AGENDA
Historic Yorktown Design Committee

SUBJECT: Application No. HYDC-272-25, County of York, Replace existing tent behind the Freight Shed with permanent pavilion and repair all doors, 331 Water Street

SUBJECT: Application No. HYDC-273-25, York County, 323Z Water Street

SUBJECT: Application No. HYDC-274-25, York County, 323Z Water Street

1. Proposed Location

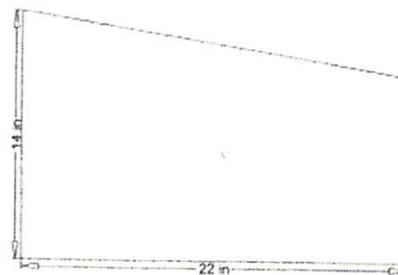
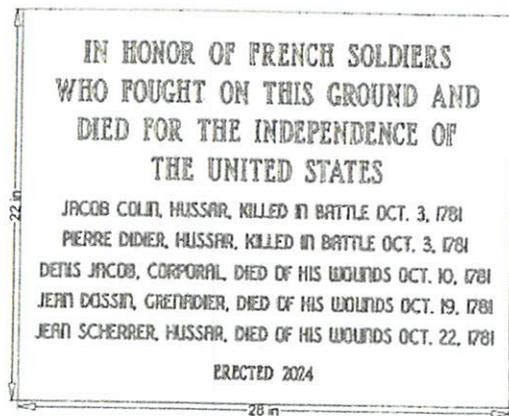
The applicant is requesting the installation of a historical marker honoring French soldiers who fought and died in the Battle of Yorktown. The sign is proposed to be located on the northwest side of the property, adjacent to the existing Lafayette’s Tour sign. The historical marker would be twenty-eight inches (28”) by twenty-two inches (22”), on a metal pole approximately five feet (5') in height.

Standard	Comments
Signs should be appropriate to the scale and design character of the residence and should not adopt thematic designs.	The proposed sign is thematically designed to match existing historical markers in Yorktown and does not meet the Guideline requirements.
Residential identification signs shall not exceed one (1) square foot in size.	The proposed sign is not a residential identification sign, but a historical marker. The sign measures 4.2 square feet in size.

Staff recommends approval of the historical marker, with the specifications/details as submitted by the applicant.

1. Proposed Location

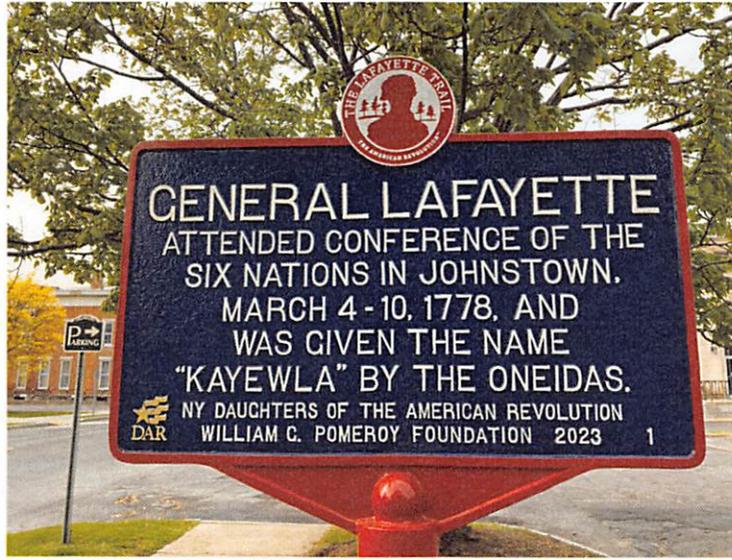
The applicant is requesting the installation of a historical marker honoring General Lafayette, specifically his disembarkation at Yorktown. The historical marker would be a three-foot (3') by two-foot (2') cast aluminum panel on two-inch (2”) by three-inch (3”) posts painted red. The sign, once placed, would be approximately four feet (4') in height.

Standard	Comments
Signs should be appropriate to the scale and design character of the residence and should not adopt thematic designs.	The proposed sign is thematically designed to match existing historical markers in Yorktown and does not meet the Guideline requirements.
Residential identification signs shall not exceed one (1) square foot in size.	The proposed sign is not a residential identification sign, but a historical marker. The sign measures six (6) square feet in size.

Staff recommends approval of the historical marker, with the specifications/details as submitted by the applicant.

1. Proposed Locations

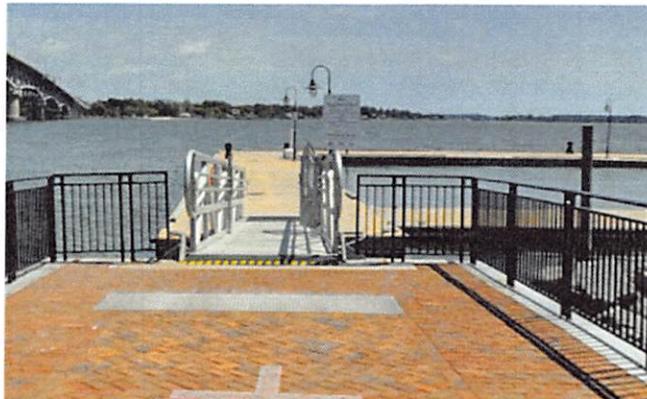
York County is working with various watershed protection groups to install a new educational sign at the three piers at the Yorktown beachfront. The Zoning Ordinance, Section 24.1-705(1), exempts “Signs located on property occupied by public...recreational uses and...not legible from adjacent streets” from the requirement to obtain an administrative sign permit. The applicant is requesting the installation of educational signs to teach the public about the York Watershed System. The signs are proposed to be located at the entrances of each pier. The signs would be ten-inch (10”) by fourteen-inch (14”) metal signs on four-by-four posts of natural wood. The signs would be placed at various heights, depending on location.

Standard	Comments
Signs should be appropriate to the scale and design character of the residence and should not adopt thematic designs.	The proposed signs are thematically designed to match other signs being used in different locations within the watershed and do not meet the Guideline requirements.
Residential identification signs shall not exceed one (1) square foot in size.	The proposed sign is not a residential identification sign, but an educational sign. The sign measures less than one (1) square foot in size.

Staff recommends approval of the educational signs, with the specifications/details as submitted by the applicant.
